From: Lucy Harrison [REDACTED]
Sent: Monday, August 12, 2024 12:12 PM
To: Poole, Rachel J [REDACTED]
Cc: Britton, Ed [REDACTED] Dave Roscoe [REDACTED] Jennifer Atkinson [REDACTED]
Subject: [EXT] Fw: LPA Reference: 137226/FO/2023 and 137227/FO/2023 Detailed Response

LPA Reference: 137226/FO/2023 and 137227/FO/2023

ATE Reference: ATE/24/00630/FULL

Site Address: Part Of Plot C And Plot E, Plot D Great Jackson Street,
Manchester, M15 4NP

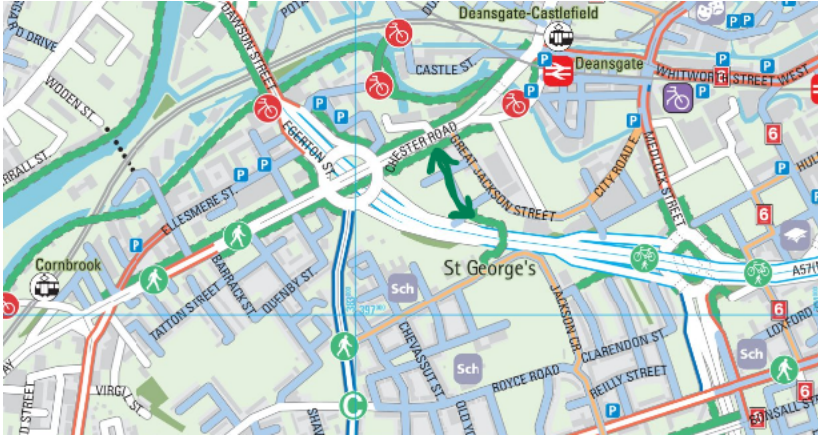
Cyclists travelling to the existing shared bridge over the A57(M) Mancunian Way from the wider cycle network will arrive from Chester Road, and via the shared route recently finished as part of Phase 2 proposals, highlighted below with a green arrow:

The following image shows the recently implemented shared pedestrian/cycle route from Melbourne Street to Chester Road through Phase 2 of the wider Masterplan:

Curtins point remains that the infrastructure proposed is suitable – in line with LTN 1/20 – and also in consistent with the design approach for Phase 2 as shown in the above image.
